Service Bulletin

SB-10057574-8899

SUBJECT: Special Coverage Adjustment – Negative Battery Cable Loose

MODELS: 2011-2015 Chevrolet Cruze

PART INFORMATION

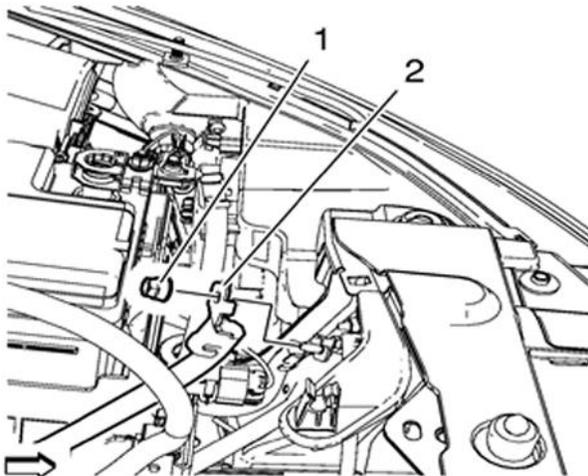
Dealers will replace the battery negative cable, which will now require a bolt to fasten the small regulated voltage cable. The repairs will be made at no charge to the customer.

Part Number	Description	Quantity/Vehicle
22754271	Cable Assembly – Battery Negative	1
11561025	Bolt – Hvy Hx Flg Hd	1
